**MONTGOMERY COUNTY HISTORIC PRESERVATION COMMISSION**  
**STAFF REPORT**

<b>Address:</b>	23312 Frederick Road, Clarksburg	<b>Meeting Date:</b>	12/20/2023
<b>Resource:</b>	Contributing Resource <b>Clarksburg Historic District</b>	<b>Report Date:</b>	12/13/2023
<b>Applicant:</b>	JASAI Properties (Ben Dorsey, Architect)	<b>Public Notice:</b>	11/1/2023
<b>Review:</b>	HAWP	<b>Tax Credit:</b>	No
		<b>Staff:</b>	John Liebertz

**PROPOSAL:** Demolition of outbuildings and construction of new daycare center, including tree removals, grading, new hardscape and other site alterations.

**C2.01**  
 PROJECT NO. 13.109.41  
 SHEET NO. 7 OF 7

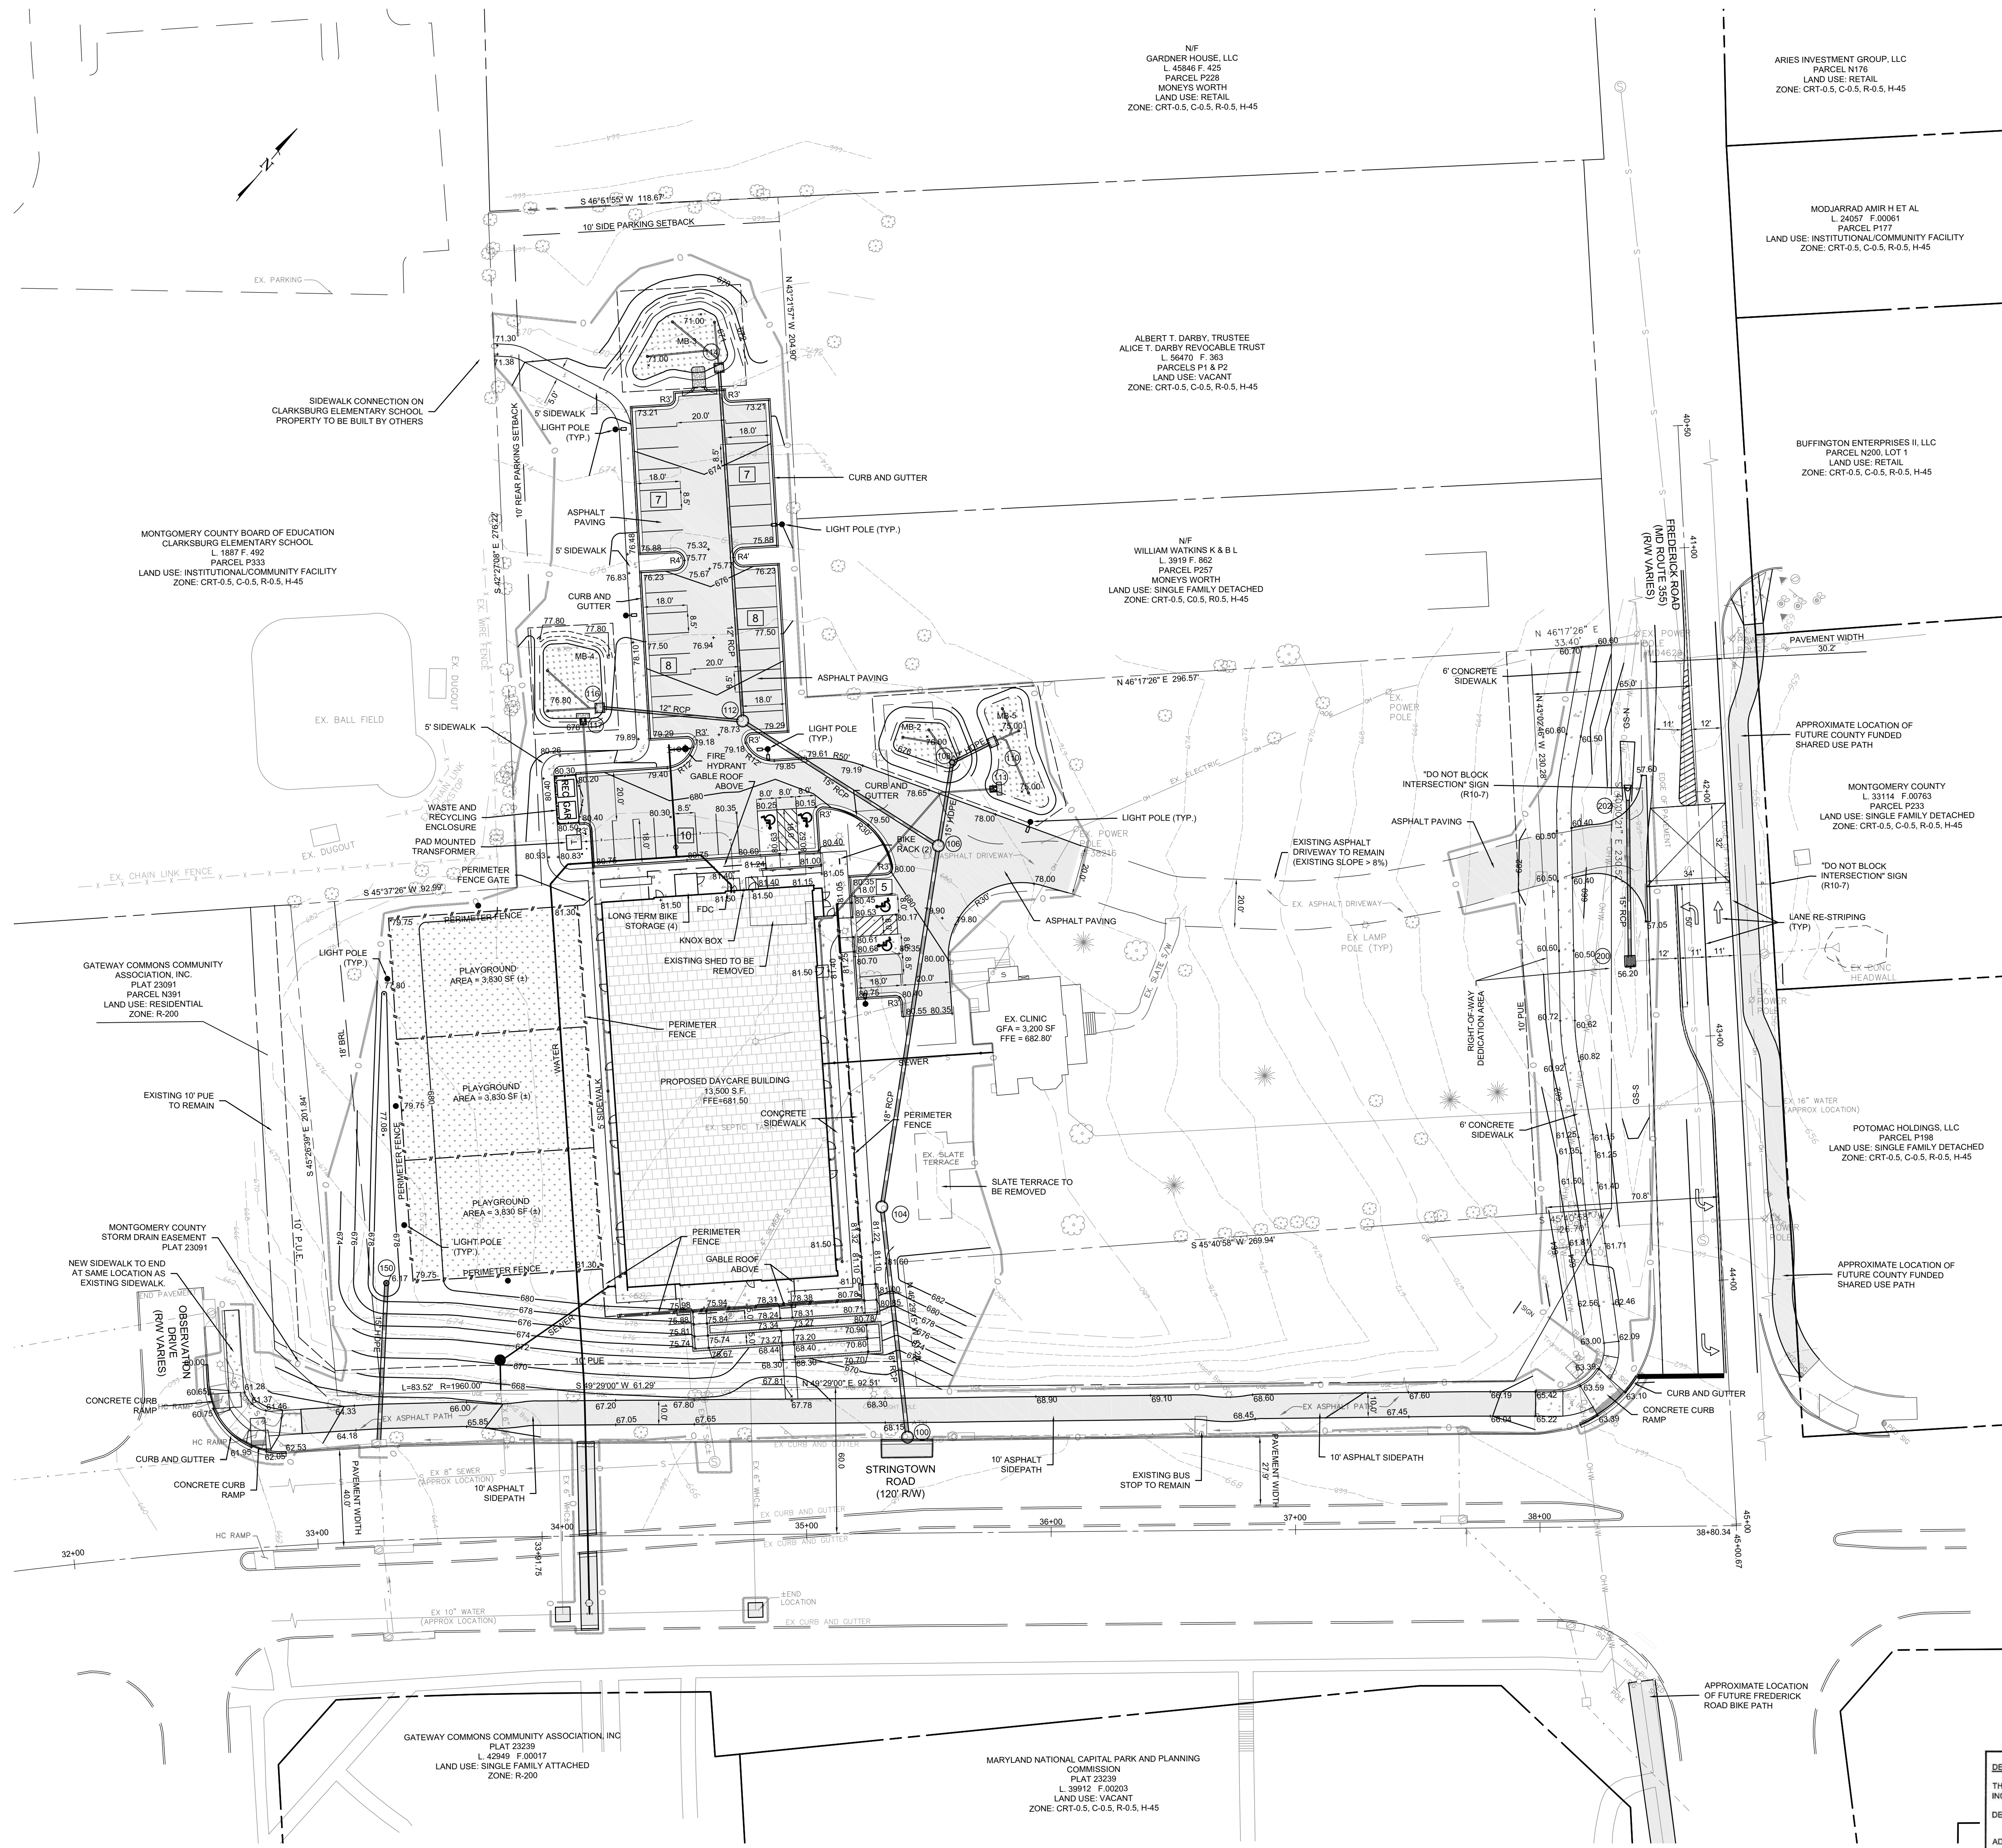
Staff requests additional information on the "waste and recycling enclosure" and "pad mounted transformer" noted on Site Plan C2.01. The applicant shall submit drawings and specifications for these elements which will be reviewed and approved by staff.

1. The applicant shall submit drawings and specifications for the “waste and recycling enclosure” and “pad mounted transformer” noted on Site Plan C2.01.
2. The applicant shall setup a pre-construction meeting with Historic Preservation staff to review material sample boards and discuss any modifications to the approved plans. This meeting shall occur prior to approval of the building permit.
